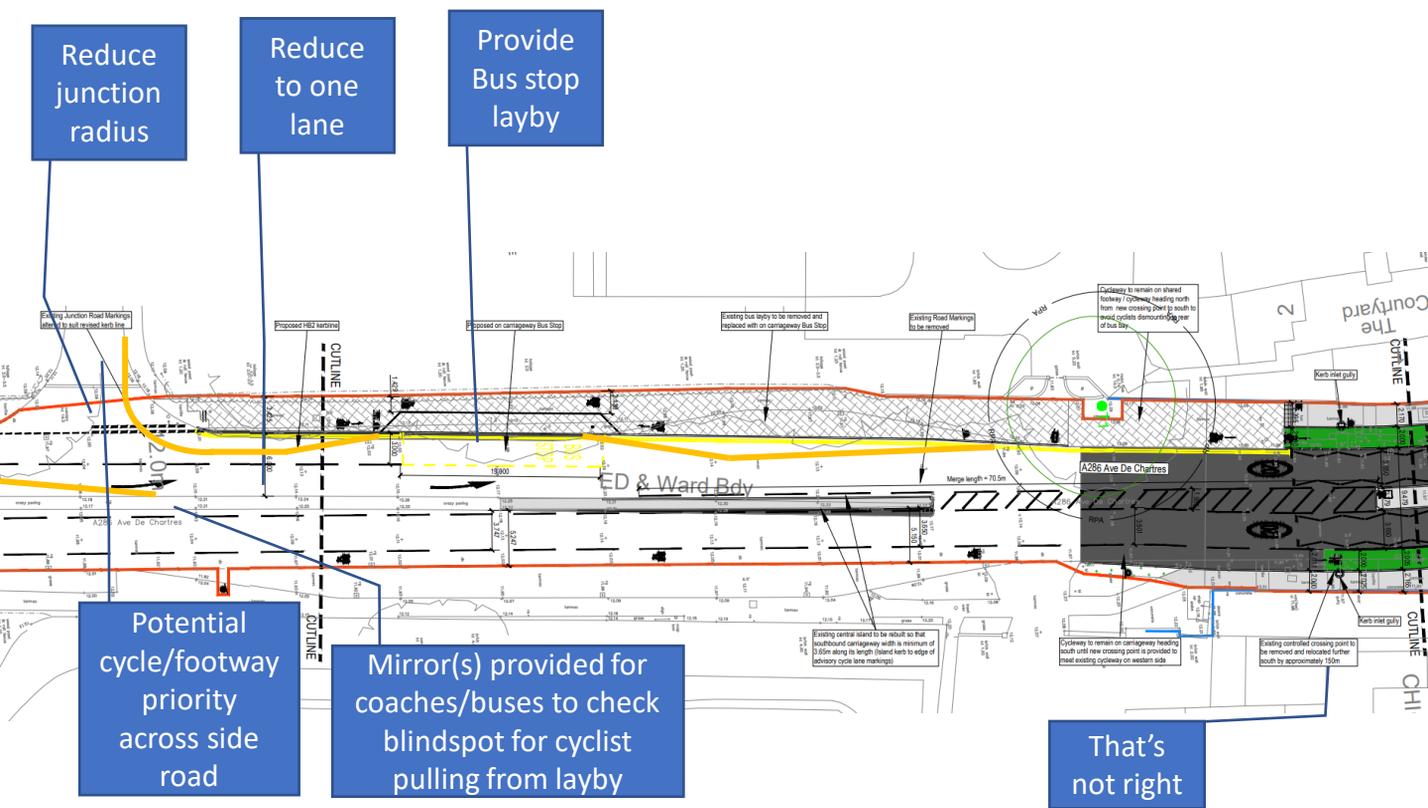
Main issue I have with the proposed crossing is that Parallel crossings are meant to be used when there is a cycle route off of the road, and not used to switch sides for cycle provision. Here it is just seemed to be used to allow southbound cyclists to switch to the shared cycle/footway on the other side of the road.

Would be better if it was located just to the south to provide a crossing where the PRoW joins/leaves the road. If this footpath was converted to allow bicycles (although at the moment there is nothing legally preventing bicycles), then it would fulfil the designed purpose of parallel crossings.

Another issue I have with it is the two-lane approach northbound. Since this reduces to one lane just the otherside of the crossing, I don't see why this could be reduced to one lane prior to the crossing.

Two lane approaches to zebra or parallel crossings should be avoided as drivers may have visibility severely impacted by adjacent vehicles. Also this would provide a wider refuge for pedestrians and bicycles from 2.5m (on drawing but labelled as 2m?) upto 4.3m, although only 3m is needed.

There should also be cycle ingress from the carriageway via dropped kerb before the crossing.

Although if the northbound carriageway is reduced to a single lane then alterations would have to be made around the bus stop, potentially putting it into a layby. Also reduction in the side road radius would reduce the speed and therefore risk to pedestrians and cyclists using the shared use path. Potentially continues footway/cycleway treatment could be given in these situations to further reduce speed. Reducing to a single lane sooner would also give more space on the shared cycle/footway, reducing conflict between pedestrians and cyclists. There is lack of works being done to reduce conflict between cyclists and busses/coaches pulling out of layby. Potentially mirrors could be provided to allow buses to check for cyclists (in the cycle lane blind spot). This plans also seems to omit the parking restrictions on the southbound carriageway between the zigzags and bus/coach parking layby.

On the roundabout itself there are many issues.

On all arms the cycleway has no segregation from the main carriageway. This poses three main issues.

The first one is that pedestrians have no refuge between crossing motor traffic arms, and the cycle track. Adding the refuge in would reduce wait times for cyclists and motor traffic as well as providing a safer crossing for pedestrians.

The second one is that cyclists wishing to leave the roundabout have to give way to pedestrians while being in the circulatory carriageway. This may result in cyclists wishing to continue around the roundabout being prevented from doing so, or could result in rear-ended another cyclist. Also cyclists waiting to join the cycleway roundabout would be stopped over the pedestrian crossing. Adding segregation in would lengthen the cycleway exit/entry allowing one bicycle to wait without holding up others or blocking the pedestrian crossing. If segregation isn't possible, the cycleway should widen on approach to provide an "exit" lane and a continue lane. See below for example.

Third issue is that it results in incorrect markings as having a "giveway" markings between the pedestrians and cycle parts of parallel crossing. This is not allowed and would make the crossing invalid in terms of enforceability in law, unless an exception was granted by DoT.

Where segregation allows, it should be done.

The North Walls arm is done very badly. Due to physical constraints its not exactly easy to come up with a solution. I'd consider just making the whole arms a shared space between pedestrians, cyclists and motor vehicles with the cycle track being the only thing marked through it. There isn't enough room there to do anything properly, so its better to not formally mark it all out except the cycle track.

The access to No 1 Orchard Street is very poor.

Private accesses of roundabouts aren't great in any situation, however here there is no capability to turn around off-highway, so the current design suggest that access is forward with reversing out back onto the roundabout. This should be the other way around with access into in reverse gear and entering the roundabout in a forward gear. Also priority isn't clear across the cycleway here.

The loading layby on West Street is partly within the crossing controlled area. The Zigzags should be reduced so they don't overlap.

Again there are arrows on the cycleways within the crossing controlled areas, this isn't allowed either.
